**CITY OF TEMPE
DEVELOPMENT REVIEW COMMISSION**

Meeting Date: 05/23/2017
Agenda Item: 3

ACTION: Request for a Development Plan Review consisting of two new buildings for **TEMPE CRANE (PL170106)**, located at 1979 East 5th Street. The applicant is Huellmantel & Affiliates.

<p>adaptive ARCHITECTS 1079 East 5th Street Tempe, AZ 85281 480.833.8888 www.adaptivearchitects.com</p>		
<p>Phase SCHEMATIC DESIGN</p>		
<p>TEMPE CRANE NEW FACILITY TEMPE, AZ</p>		
<p>SITE PLAN</p>		
Project Number: 1708	Revision Date:	Sheet Number: SP1.2
Date: 5-1-17

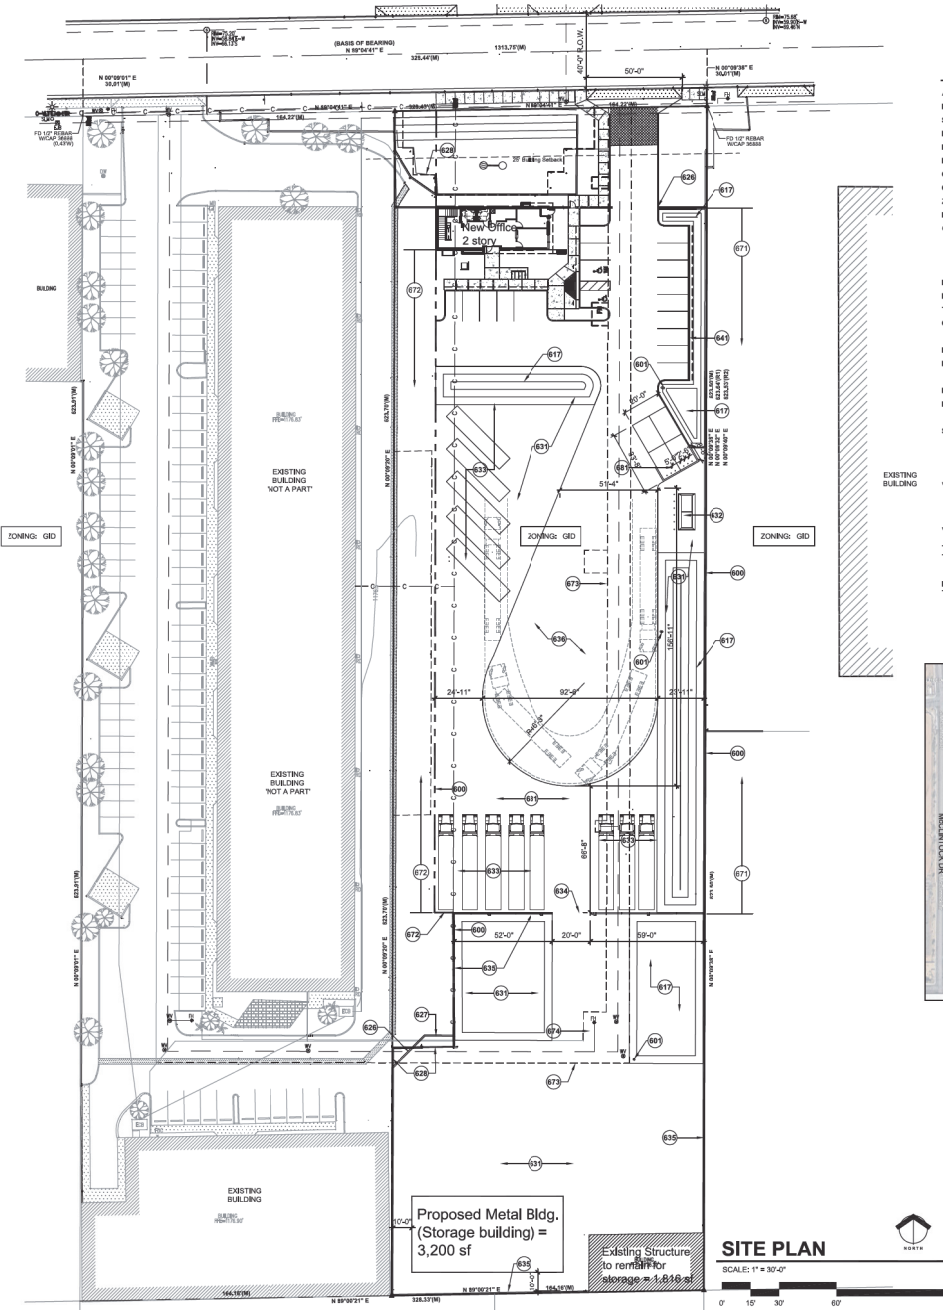
3. Proposed fire hydrant must be relocated; shall not be placed within sixteen (16) feet of a building/structure or tree, subject to approval of the Fire Department.
4. Light poles should not be placed within twenty feet of trees.
5. A dual refuse enclosure shall be provided and dedicated for both trash and recycle.
6. Provide gates with vision panels for refuse enclosure.
7. Pedestrian gate to access site should be equipped with a vision panel.

8. Provide service yard and mechanical (cooling tower/generator) yard walls that are at least 8'-0" tall as measured from adjacent grade and are at least the height of the equipment being enclosed, whichever is greater. Verify height of equipment and mounting base to ensure that wall height is adequate to fully screen the equipment. Locate electrical service entrance sections inside the service yard, as indicated.

10. Provide upgraded paving at each driveway consisting of integral colored unit paving; or integral colored concrete that is scored or stamped with a decorative pattern. Extend this paving in the driveway from the right-of-way line to 20'-0" on site and from curb to curb at the drive edges. From sidewalk to right-of-way line, extend concrete paving to match sidewalk.

NORTH BUILDING ELEVATION

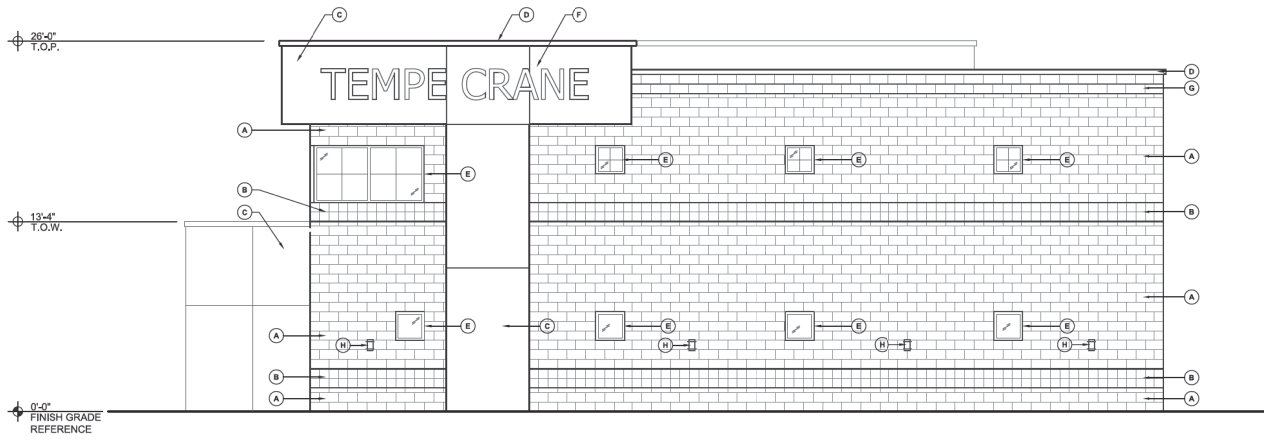
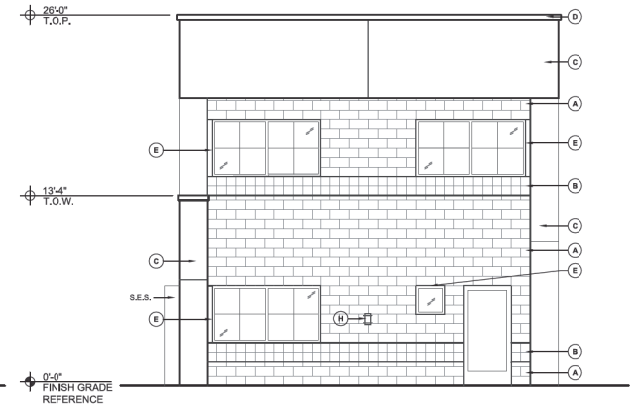
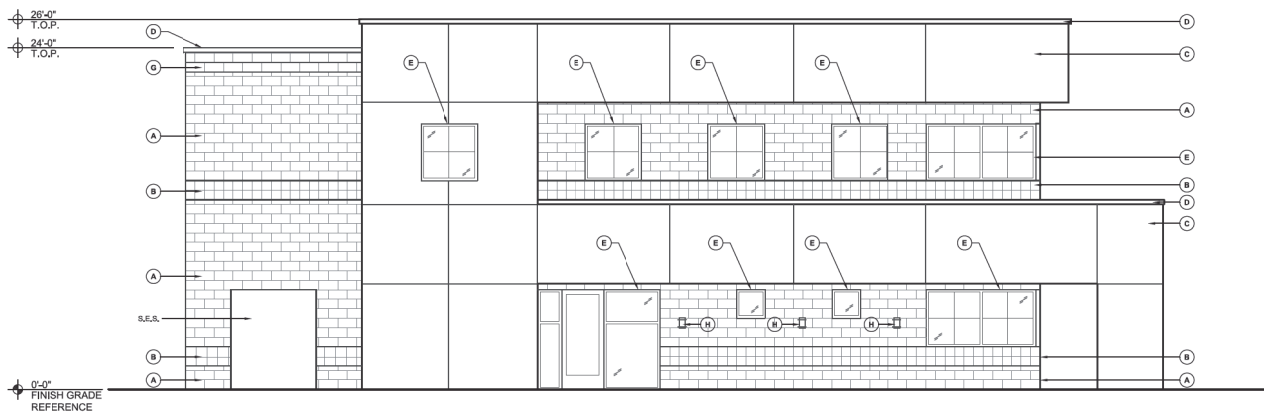
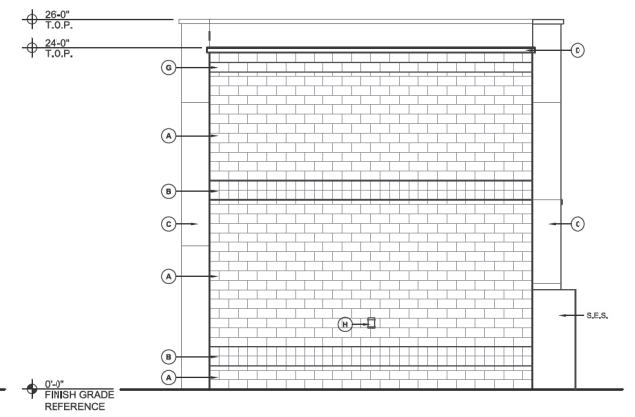
15. The materials and colors are approved as presented:

16. The new metal storage building shall not exceed thirty-five (35) feet, as measured from grade.
17. EIFS should be integral color, not painted.
18. Proposed metal storage building shall be restored and if required, repainted to match existing colors as shown on Attachments 18 and 19.
19. Existing building onsite shall be painted to match the proposed metal storage building.

20. Provide secure roof access from the interior of the building. Do not expose roof access to public view.
21. Conceal roof drainage system within the interior of the building.
22. Incorporate lighting, address signs, and incidental equipment attachments (alarm klaxons, security cameras, etc.) where exposed into the design of the building elevations. Exposed conduit, piping, or related materials is not permitted.
23. Locate the electrical service entrance section (S.E.S.) inside the building or inside a secure yard that is concealed from public view.
24. Upper/lower divided glazing panels in exterior windows at grade level, where lower glass panes are part of a divided pane glass curtain-wall system, shall be permitted only if laminated glazing at these locations is provided.

CONCEPTUAL LANDSCAPE PLAN

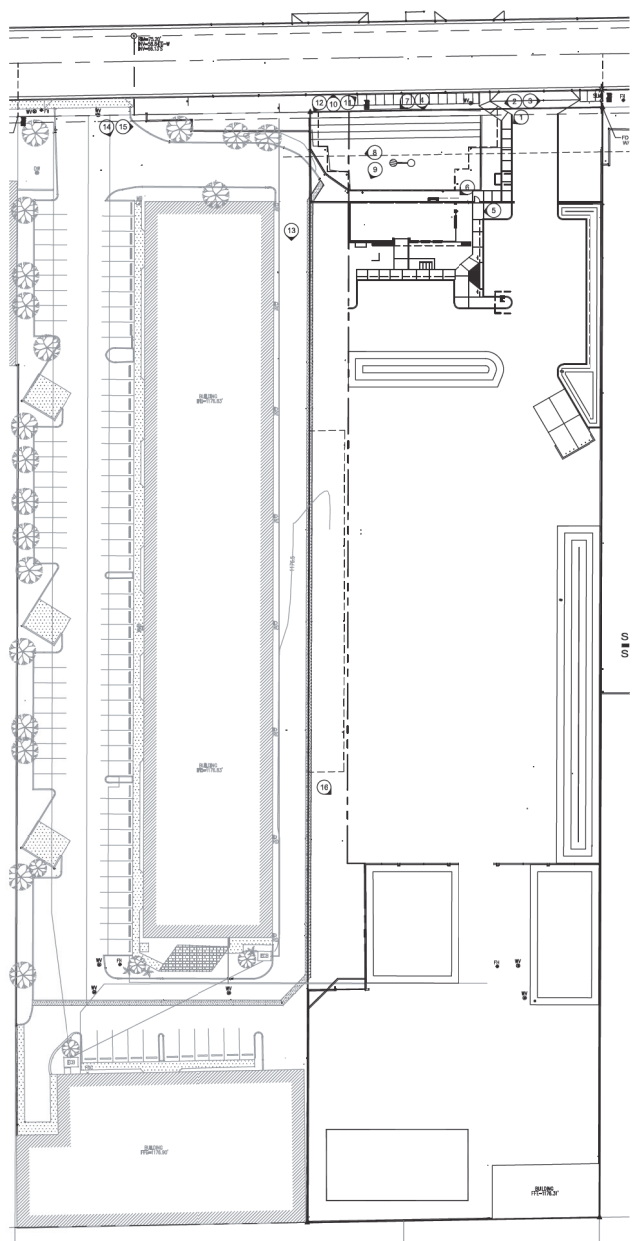
27. Street trees shall be specimens with a minimum of 1 ½" caliper trunk.
28. Project should incorporate one or more of the tree species listed below in lieu of proposed street trees.

29. One (1) of the Thornless Mesquite trees (will be a different tree species per Condition #26) just south of the landscape setback line shall be shifted north of this line, all other trees shown north of the landscape setback line shall remain.

30. The ends of all parking rows shall conform to Section 4-704C (Parking Lot Landscape Dimensions) of the ZDC.
31. Provide a minimum of fifty percent (50%) vegetative ground cover to all landscape areas, with exception to the required land use tree buffer required along the rear property line.

34. Top dress planting areas with a rock or decomposed granite application. Provide rock or decomposed granite of 2" uniform thickness. Provide pre-emergence weed control application and do not underlay rock or decomposed granite application with plastic.
